# **8XC196KC SPECIFICATION UPDATE**

Release Date: March, 1997

Order Number: 272834-003

The 8XC196KC may contain design defects or errors known as errata. Characterized errata that may cause the 8XC196KC's behavior to deviate from published specifications are documented in this specification update.

### ***9600011. Write Cycle During Reset***

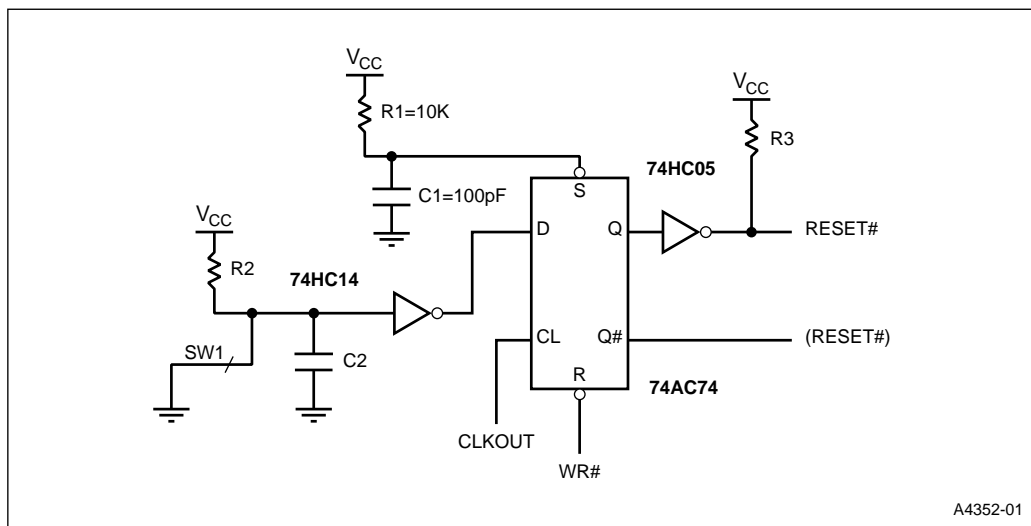
**WORKAROUND:** Allow reset to occur only at the rising edge of CLKOUT and only if WR# is high. If a reset occurs during an external bus write cycle, RAM data on the external bus may be corrupted. This describes a logic design that will alleviate the problem.

The following circuit will allow a manual reset to occur at the rising edge of CLKOUT only if WR# is high (inactive). If WR# is low (active) then RESET# will stay high (inactive). The 74HC14 and 74HC05 are usually already in the system, so the only additional components are the 74AC74, R1, and C1.

**Notes:**

1. R1 = 10K ohms and C1 = 100 pF.
2. R2 and C2 should allow for reset state times plus write wait states.

If software resets can occur, use RESET#. If no software resets will occur, eliminate the 74HC05 and use (RESET#).

The  $R1 \cdot C1$  time constant is one microsecond to ensure that the flip-flop comes up 'on' after a power-up. The reset flip-flop at the rising edge of CLKOUT after the  $R2 \cdot C2$  time constant has expired.

For manual resets, the flip-flop will turn on at the next rising edge of CLKOUT unless WR# is low. If WR# is low, the flip-flop turn on will be delayed until the next rising edge of CLKOUT when WR# is not low. This may occur after any number of wait states. The R2\*C2 time constant must be long enough for the normal reset state times plus the maximum number of write wait states.

**Figure 1. Options for Decreasing Noise Sensitivity**

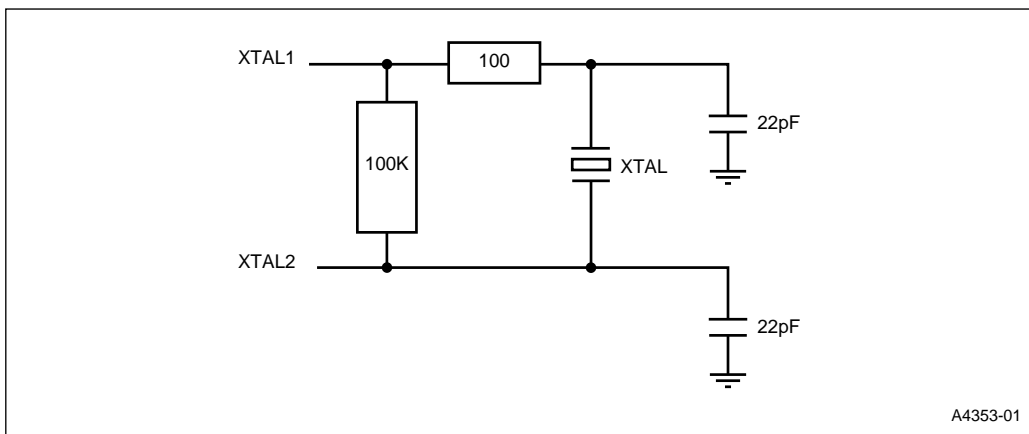
**PROBLEM:** The oscillator may enter a mode in which the peak-to-peak voltage may not be great enough to consistently trigger the internal clock circuits. This gets worse with ceramic resonators, high temperature, socketed parts, or boards without ground planes.

The oscillator can change from one state to another if there is an appreciable change in the noise level between  $V_{SS}$  (core ground) and  $V_{SS1}$  (port ground). This could occur at device reset, when changing multiple port lines simultaneously, or when switching relays or other high current devices.

1. Use a crystal instead of a ceramic resonator.
2. Use a multi-layer board with dedicated power planes.
3. Solder the 80C196KC directly to the PC board; do not use a socket.
4. Locate the crystal as close to the device as possible and keep the XTAL board traces less than 1 cm each.
5. Tie  $V_{SS}$  and  $V_{SS1}$  together through the lowest possible impedance path.

6. Decouple each  $V_{SS}$  and  $V_{SS1}$  pin to  $V_{CC}$ .
7. Place a 100 K resistor between XTAL1 and XTAL2. (See Figure 1.)
8. Place a 100 K resistor in series between XTAL1 and the crystal. (See Figure 1.)
9. Thoroughly test each system over its operating range.
10. Use an external oscillator if possible.

Some or all of these suggestions should allow the oscillator to function properly in a system. We have had no reported failures over commercial temperatures ( $0^{\circ}$  to  $70^{\circ}\text{C}$ ) in designs using suggestions 1 through 6.

**Figure 3.**

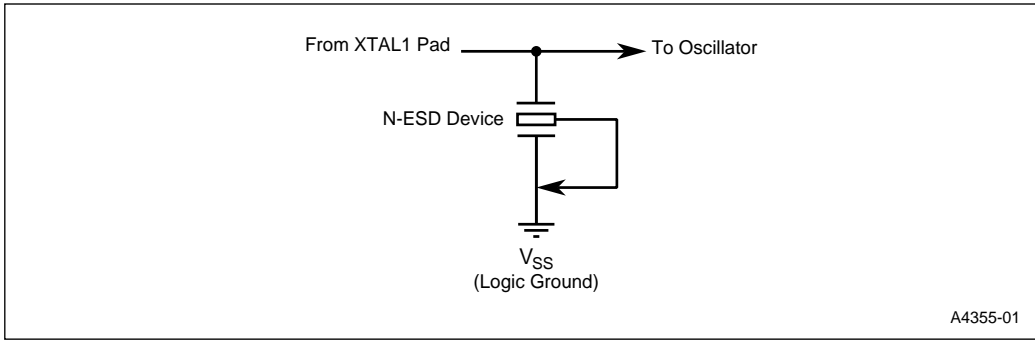
To eliminate the noise sensitivity, the source of the  $n$ -channel ESD device is connected to  $V_{SS}$  instead of  $V_{SS1}$ . The 80C196KC B-3 stepping with a 'C' topside marking implemented

the change in a tape-out in early January, 1991. This is a simple metal mask change that ties both the gate and source of the  $n$ -channel ESD device to a common, local ground as shown in Figure 3:

**006. Page 11-3**

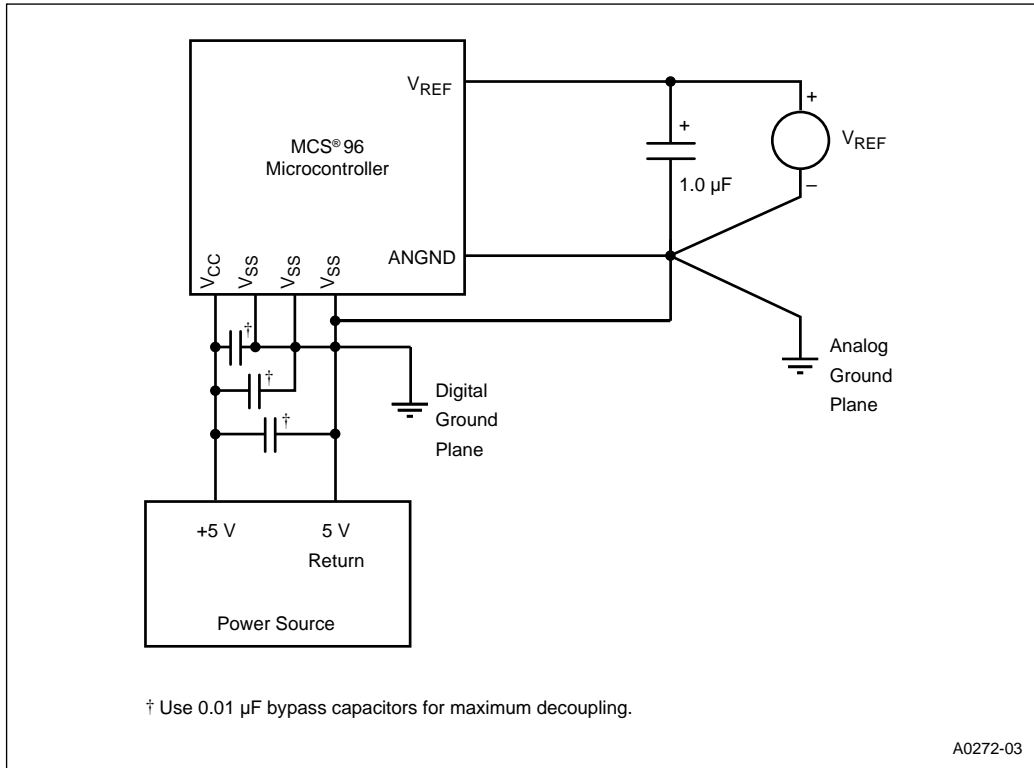
**PROBLEM:** In Figure 11-2, the recommended capacitor value between  $V_{CC}$  and  $V_{SS}$  is 0.01  $\mu\text{F}$  or greater. Also the recommended capacitor value between  $V_{REF}$  and ANGND is 1.0  $\mu\text{F}$ .

Section 11.2.1 explains the reason for these capacitors. However, the second to last line of the first paragraph should read as follows: 'Connect a 0.01- $\mu\text{F}$  bypass capacitor between  $V_{CC}$  and each  $V_{SS}$  pin and a 1.0- $\mu\text{F}$  capacitor between  $V_{REF}$  and ANGND.'

**Figure 4. Serial Port Block Diagram**

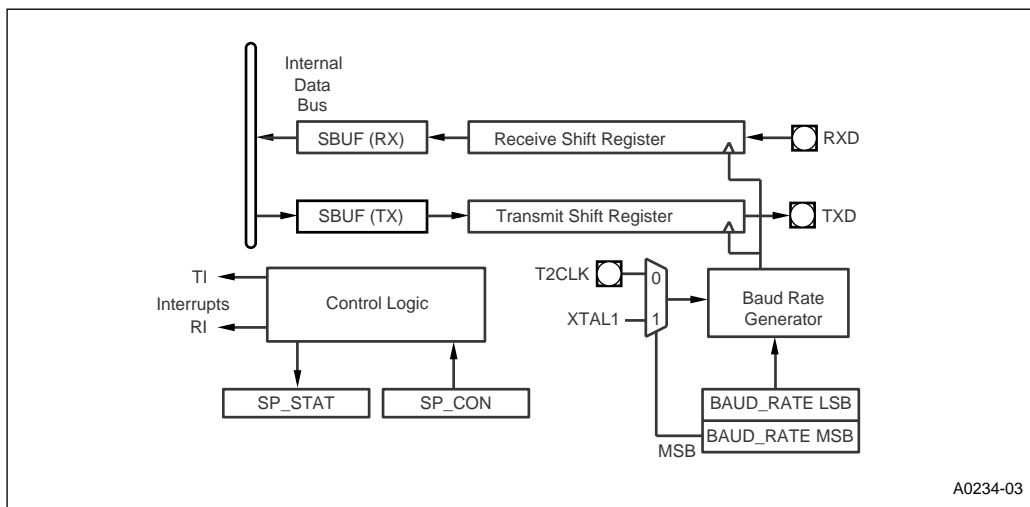
**ITEM:** The following block diagram will be included in future manuals.

**025. Page 11-2**

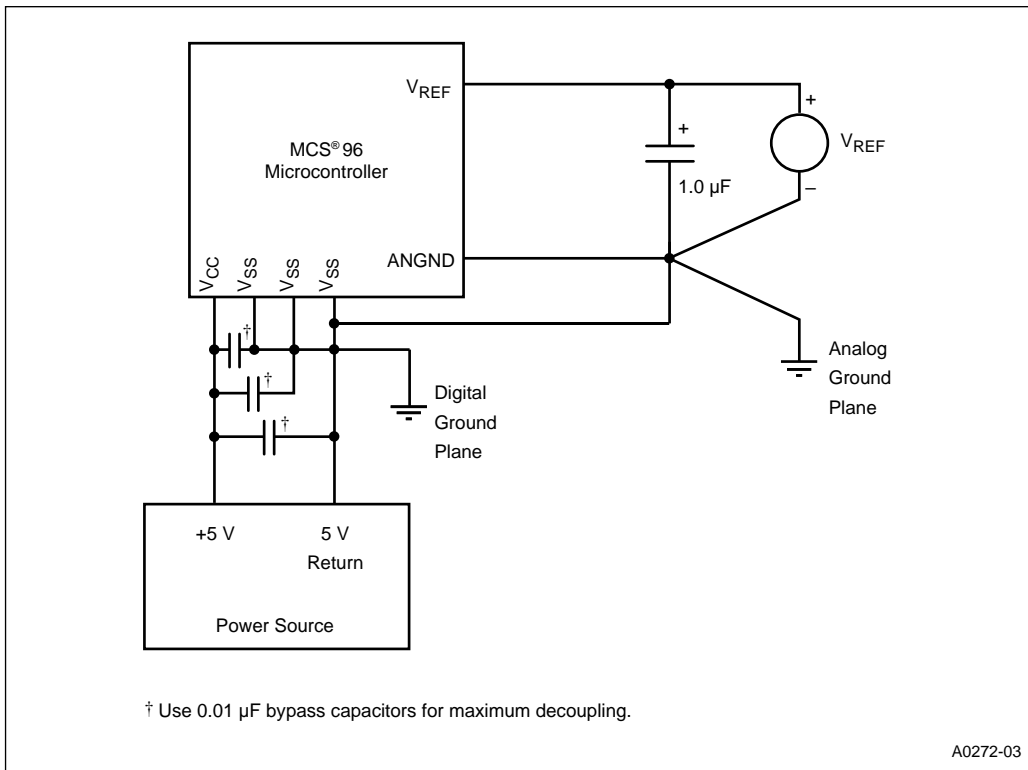
**ITEM:** In Figure 11-1, the recommended capacitor value between  $V_{CC}$  and  $V_{SS}$  is **0.01  $\mu\text{F}$**  or greater. Thus, the 0.1  $\mu\text{F}$  capacitor shown can be used.

Figure 11-6. External Clock Drive

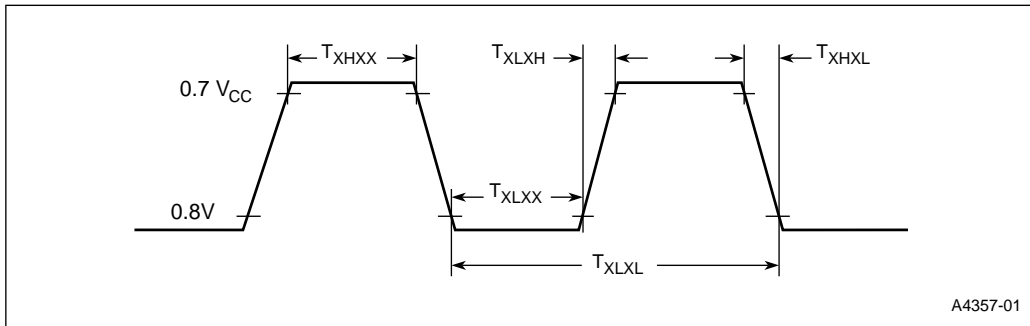
**ITEM:** In Figure 11-6, the timing diagram incorrectly represents the  $T_{XLXL}$  and  $T_{XHXL}$  timing specifications. The timing diagram below replaces Figure 11-6.

Figure 11-8. Reset Pin Internal Circuit

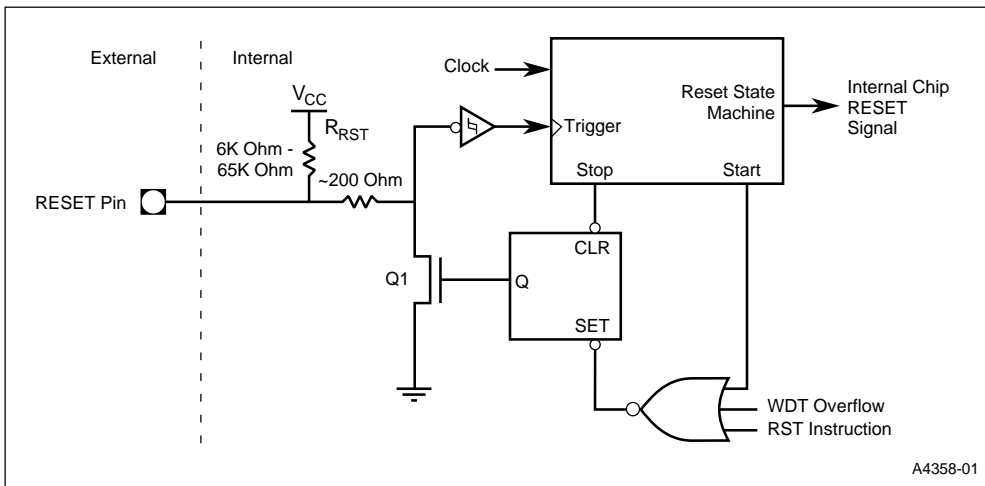
**ITEM:** Figure 11-8 shows the reset pin internal circuit. However, there are a couple of mistakes; the following figure shows the corrected version. The **inverter** at the Reset State Machine’s Trigger input and the **OR gate** at the SET input of the latch are the corrections to this figure.
